Project	<b>IEEE 802.16 Broadband Wireless Access Working Group</b> < <a href="http://ieee802.org/16">http://ieee802.org/16</a> >	
Title	Sleep mode supporting the periodic ranging with compressed format of SLP ID fields in MOB_TRF-IND message – Harmonization Ad-Hoc Consensus Contribution	
Date Submitted	<b>2004-08-17</b>	
Source(s)	Yeongmoon Son, Kanggyu Lee Samsung Electronics	Voice: +82 31 279 5845 ym1004.son@samsung.com
	Vladimir Yanover Alvarion Ltd.	Voice : +972 364 57834 vladimir.yanover@alvarion.com
	Yigal Eliaspur, Assaf Mor, Sharon Intel	Voice : +972 547 884877 yigal.eliaspur@intel.com
	Yongjoo Tcha, Seong-Choon Lee KT	Voice : +82 2 526 6155 yjtcha@kt.co.kr
	San-Yun Han, Jae-Hak(Steve) Lee SOLiD Tech., Inc	Voice : +82 2 2142 3881 syhan@st.co.kr
	Phillip Barber Broadband Mobile Technologies, Inc.	Voice: +1 (972) 365-6314 pbarber@BroadbandMobileTech.com
	Kiseon Ryu, Yongho (Ronny) Kim, Kihyoung Cho, Beomjoon Kim, Changjae Lee, LGE	Voice : +82 31 450 4387 beom@lge.com

# Sleep mode supporting the periodic ranging with compressed format of SLP ID fields in MOB\_TRF-IND message (Harmonization Ad-Hoc Consensus)

**Figure 1. The proposed operation of periodic ranging during sleep mode**

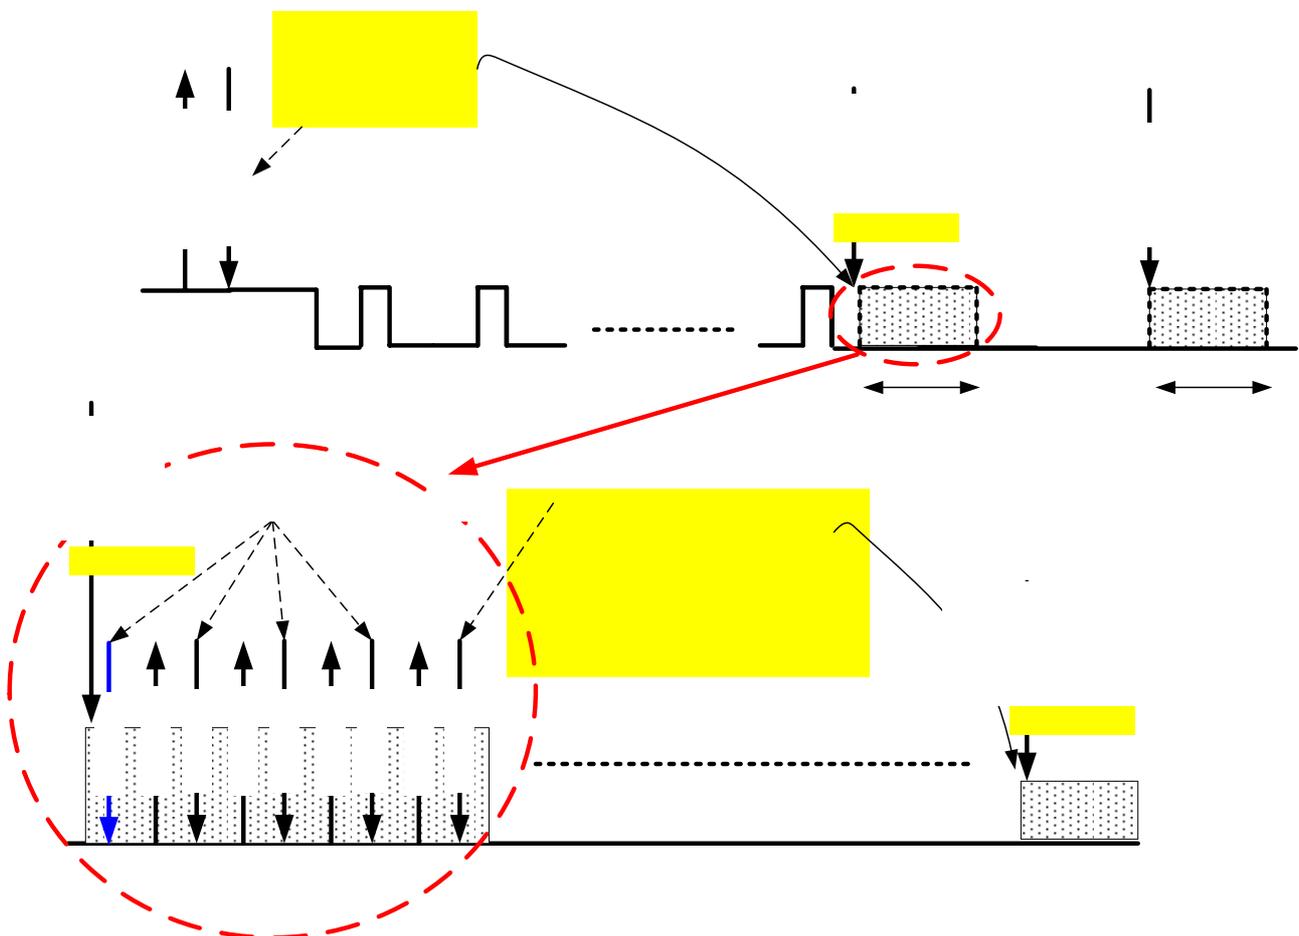
When MSS sends MOB\_SLP-REQ message to BS in order to enter sleep mode, BS shall send MOB\_SLP\_RSP including 'Next Periodic Ranging' so that MSS can know when to awaken during sleep interval for performing periodic ranging. Thus, if MSS is still sleeping in that frame whose frame number is the 'Next Periodic Ranging', it shall listen downlink frame and decode the DL-MAP and UL-MAP for periodic ranging

When the periodic ranging operation between MSS and BS comes to an end, BS shall inform MSS of the frame number in which next periodic ranging operation is expected to start. For this situation, BS shall append 'Next Periodic Ranging' as TLV encoding to RNG-RSP message whose ranging status parameter is set to 'success'. In other words, if an MSS receives the last RNG-RSP message that indicates the successful termination of the periodic ranging operation, it shall read the frame number in which next periodic ranging will start. Thus, if MSS is still in sleep interval just after completion of periodic ranging, it may return to sleep mode till the frame as 'Frame Number for Next Periodic Ranging'.

Figure 1 depicts the proposed operation of periodic ranging during sleep mode.
